HOUSTON LIGHTING AND POWER COMPANY  
SOUTH TEXAS PROJECT ELECTRIC GENERATING STATION UNIT ONE  
LICENSE NO. NPF-76

SEMIANNUAL RADIOACTIVE EFFLUENT RELEASE REPORT

MARCH 8, THROUGH JUNE 30, 1988

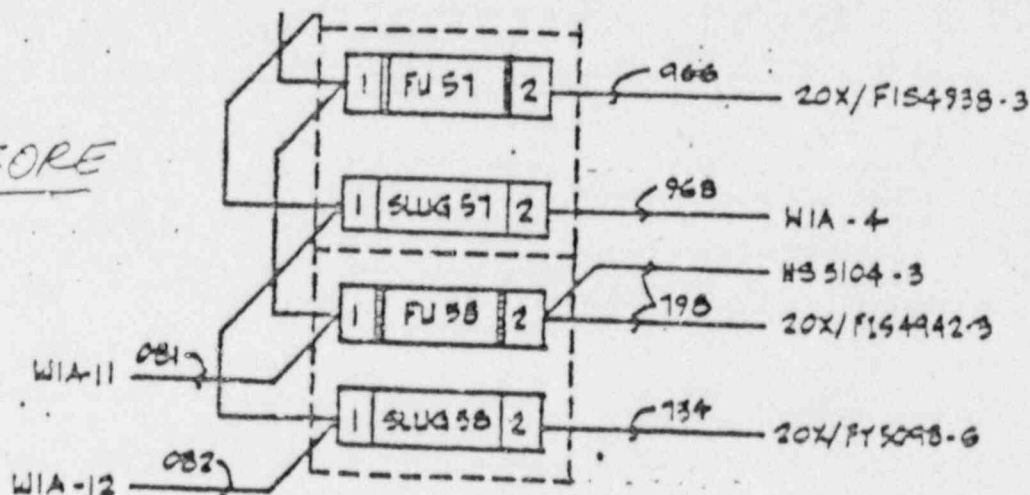
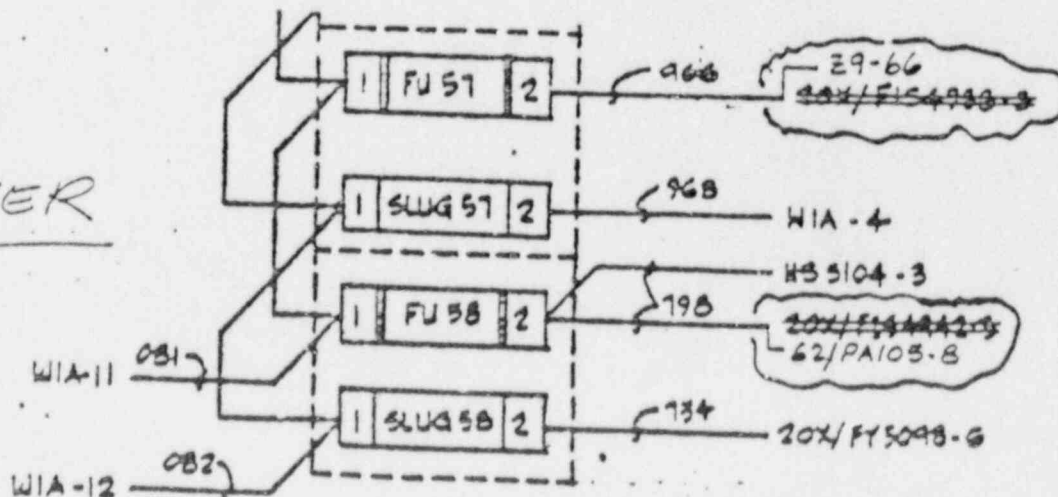
DESCRIPTION OF CHANGE:

REVISE AS SHOWN.BEFOREAFTER

DRAWING NUMBER		SHEET NO.	REV. NO.	DCN CONV.	
4089-00123-IC		-	E	DATE:	
				DWG. REV.	DCN NO.

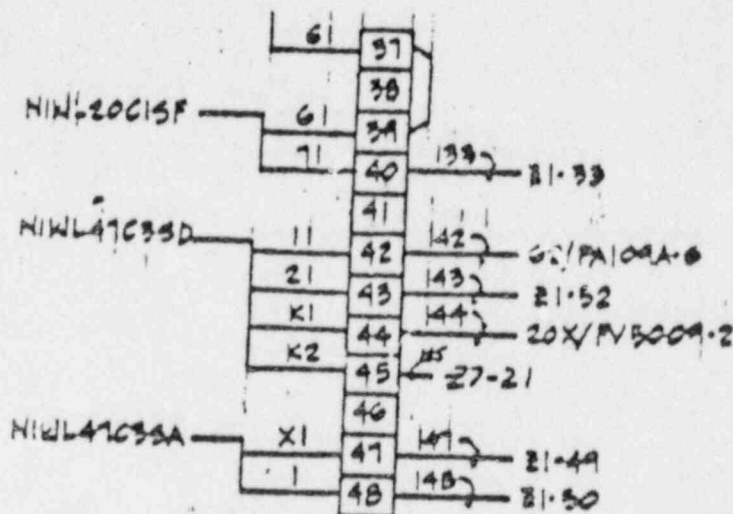
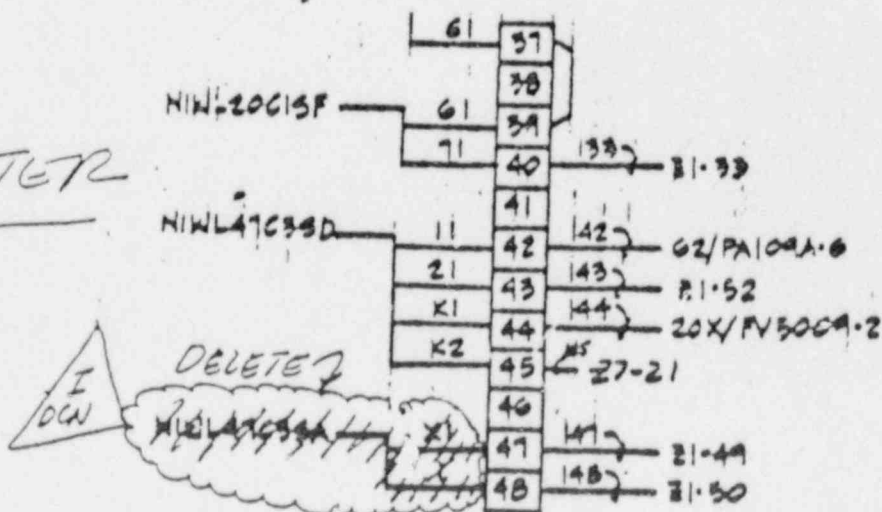
BEFORE

AFTER

DCN CONV.			
DATE:			
DRAWING NUMBER	SHEET NO.	REV. NO.	DCN NO.
4089-00124-IC	-	E

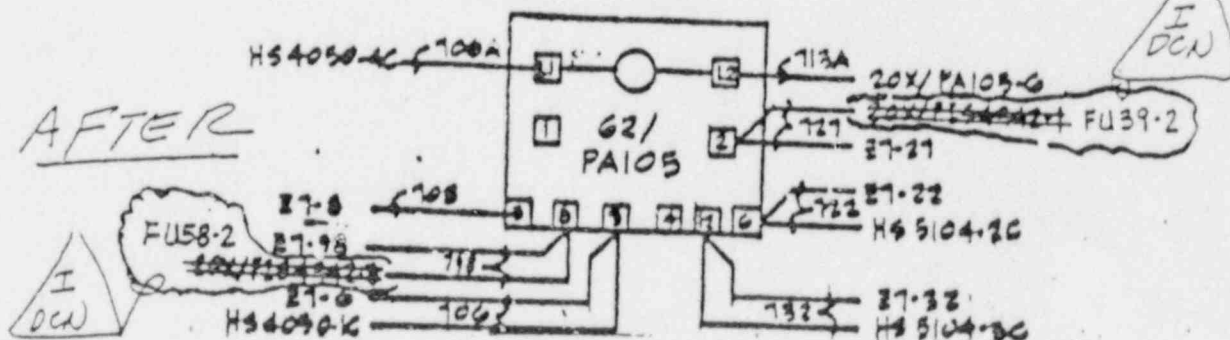
STARTUP SYSTEMS AFFECTED: 1W605JOB NO. 14926 PAGE 1 OF 2FSAR CHANGE REQUIRED? YES ☐ NO ☒REASON FOR CHANGE (Please be specific) NUISANCE ALARMS  
GENERATED BY SKID MOUNTED PRESSURE AND  
FLOW SWITCHESREF. CALL # 1358 & #1595DESCRIPTION OF CHANGE REVISE TERMINATIONS AS SHOWN:BEFOREAFTER
